Access Compliance Report Public Rights-of-Way (Curb Ramps)

Main Street: CLE GRANDE		Cross Street: CHAPMAN_AVE		Location:	SW
ADA ID: RPAT210927090219	Ramp Type: Type 4 - Parallel	Initial Pass/Fail: Fail	Overall Compliance: No	Severity Score:	19
Codes/Mitigation Info/Possible Solution			Field Measurements/Component Compliance

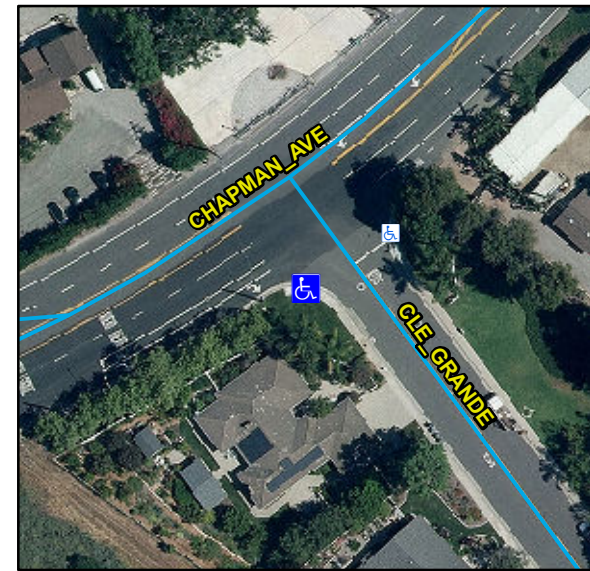
Compliance	Description	Data	Compliance	Description	Data
N/A	Ramp Length LT (in)	88	N/A	Ramp Length RT (in)	113
No	Ramp Width LT (in)	42	No	Ramp Width RT (in)	42
Yes	Ramp Run Slope LT (%)	5	Yes	Ramp Run Slope RT (%)	6.9
Yes	Ramp Cross Slope LT (%)	0.7	Yes	Ramp Cross Slope RT (%)	1.8
N/A	Landing Present	N/A	N/A	DWS Provided	N/A
N/A	Landing Length (in)	N/A	N/A	DWS Contrast	N/A
N/A	Landing Width (in)	N/A	N/A	DWS Length (in)	N/A
N/A	Landing Run Slope (%)	N/A	N/A	DWS Full Width	N/A
N/A	Landing Cross Slope (%)	N/A		DWS Offset Type	N/A
N/A	Landing Movement Obstructed?	N/A	N/A	DWS Offset Left (in)	N/A
	Landing Movement Type	N/A	N/A	DWS Offset Right (in)	N/A
N/A	Landing Shared	N/A			
N/A	Clear Space	N/A			
N/A	Clear Space To Crosswalk (in)	N/A			
N/A	Marked Crosswalk 1	No	N/A	Marked Crosswalk 2	N/A
	Crossing 1 Direction	E		Crossing 2 Direction	N/A
	Marked Crosswalk 1 Width (in)	N/A		Marked Crosswalk 2 Width (in)	N/A

Remove & Replace Entire Ramp.

R304.5.1, R302.7, STD 1115
